Addendum – Response to Submissions and Heritage Impact Statement**Sumatran Tiger Adventure – Original / Early Pathway****Introduction**

An expanded Sumatran Tiger Exhibit is proposed at Taronga Zoo. Additional information was requested on 15 September by the Department of Planning and Environment regarding the removal of part of the early path alignment (item 99L) namely:

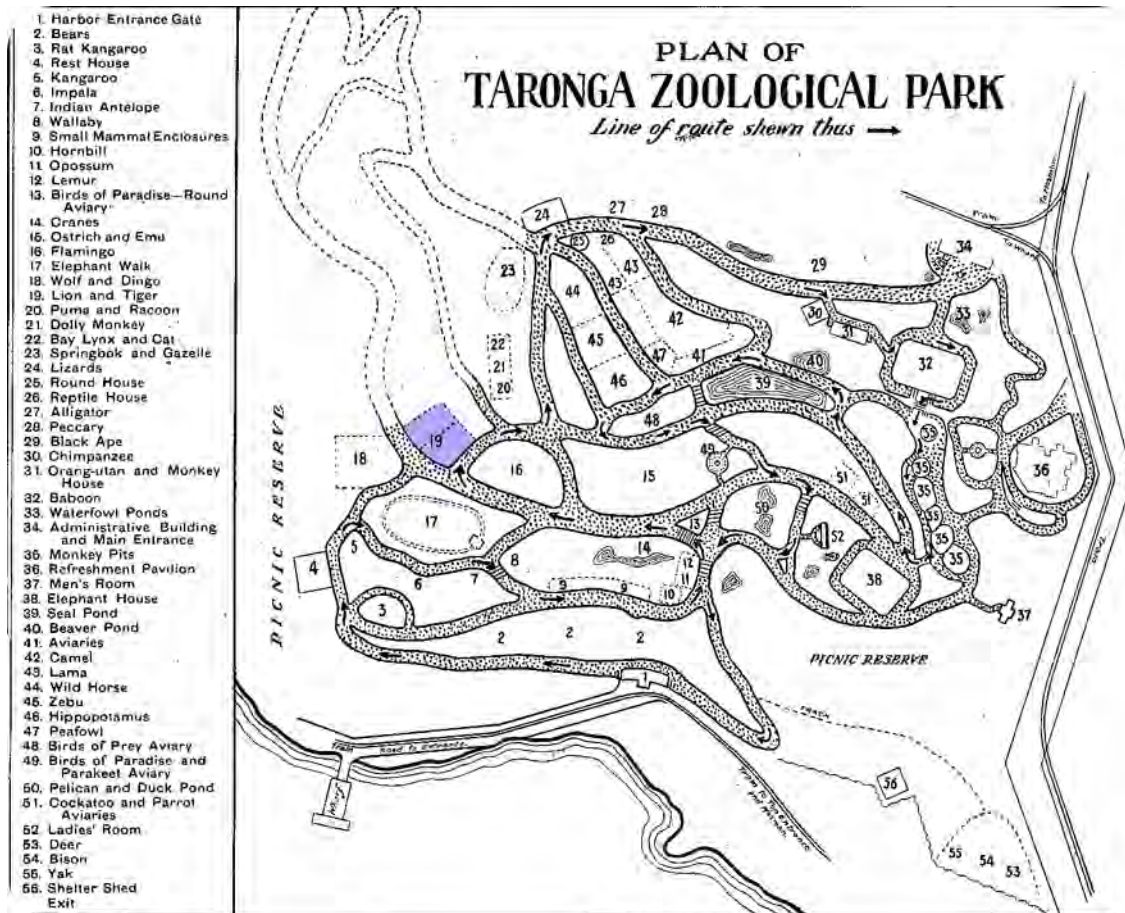
Assess the severity of the impact on the item

Assess the acceptability or otherwise of the impact in the context of the benefits, impacts and justification of the project as a whole;

Discusses the feasibility of retaining and reusing the existing path in exhibit, retaining the path but building over it, or otherwise interpreting it within the exhibit; and

If the addendum HIS concludes that the removal is unavoidable and acceptable, a discussion of potential mitigation measures and their benefits and impacts.

The item is the original early path layout 99L throughout the whole of the Zoo and was added to the s170 register and assessed as having Exceptional significance in the 2002 Conservation Strategy. Though there are paths remaining on these alignments throughout the Zoo finishes are generally modern replacements, as is typical for bitumen which needs periodic replacement, or have been altered to brick. The path in the vicinity of the proposal was built over time as exhibits were added. It is a small part of the overall path network - 99L.

The preceding analysis indicates that not all the path impacted by the proposal is original. Some sections were added to the original path network at different times and have been altered in more recent years and trenched for services installations and upgrades. The surfaces are of recent origin having been altered and resurfaced when adjacent exhibits were redone in the late 20th century. The kerbs and gutters are all modern profiles and construction. The proposal removes portions of the existing roadway in the centre of the exhibit. The area of path to be removed includes the alignment of the original but has been widened and the fabric is not original. Portions of the current path will be retained at the east and west of the site.

The proposed change to the path in this proposal does not reduce the significance of the whole original early path layout 99L which would retain its overall exceptional significance. The area impacted is a small section of the path and was not part of the through route at the Zoo (indicated by the arrows in the 1920s plan). Until Tahr Mountain and the adjacent steps (now demolished) were later constructed it was a dead end path – Birdshow Road is much more recent.
